ADDRESS: 4221 PINE ST

Proposal: Legalize replacement of slate mansard with brown asphalt shingles

Review Requested: Final Approval Owner: Gina and Thomas Ross

Figure 2. 4221 Pine Street mansard roof, December 2022.

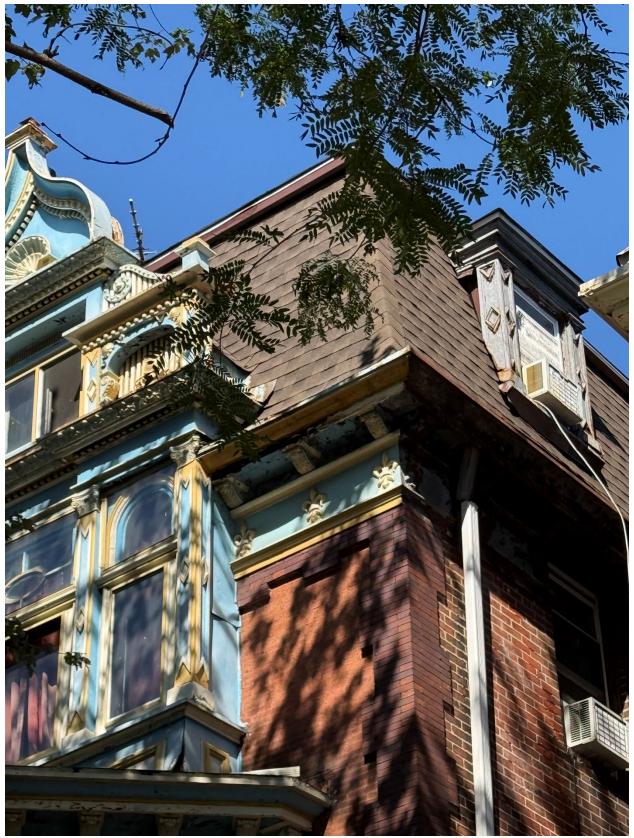
According to the National Park Service's Preservation Brief #29, slate roofs have a lifespan of 60 to 125 years. Section 6.10.c.4 of the Commission Rules & Regulations states that "the staff shall review and may approve without referral to the Architectural Committee and the Commission permit applications proposing the replacement of slate roofing materials, with the exception of mansards, turrets, and other character-defining features, provided the severity of deterioration requires replacement and the substitute materials closely approximate the color and shape of the historic slate roofing materials." The Historical Commission staff acknowledges that the slate on the mansard reached the end of its lifespan, but it would have been unable to administratively approve a brown fiberglass asphalt shingle as a replacement, had this application been submitted as a building permit application for review in advance of the work commencing.

- Standard 6: Deteriorated historic features will be repaired rather than replaced. Where the severity of deterioration requires replacement of a distinctive feature, the new feature will match the old in design, color, texture, and, where possible, materials. Replacement of missing features will be substantiated by documentary and physical evidence.
  - The brown GAF Timberline HDZ fiberglass asphalt shingles do not match the old in design, color, texture, or materials. This application fails to satisfy Standard 6.

**STAFF RECOMMENDATION:** Denial, pursuant to Standard 6.

Figure 3. 4221 Pine Street with new shingles installed, November 2025.

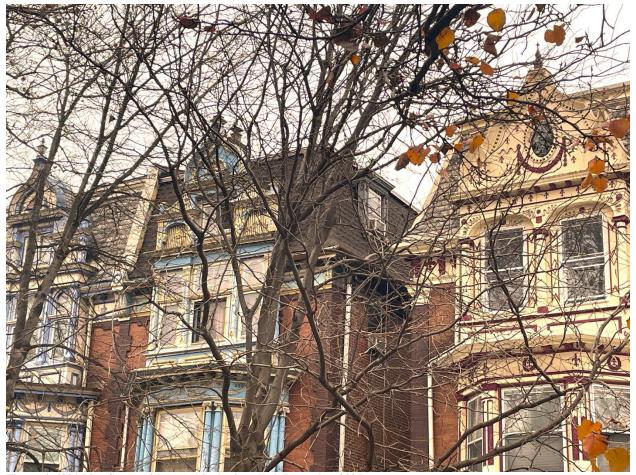
In November 2025, a community member contacted the Historical Commission to inform it of the recent replacement of slate with brown fiberglass asphalt shingles at this property. The Department of Licenses and Inspections issued a violation for the roofing work without a building permit, prompting this request for legalization from the property owner.
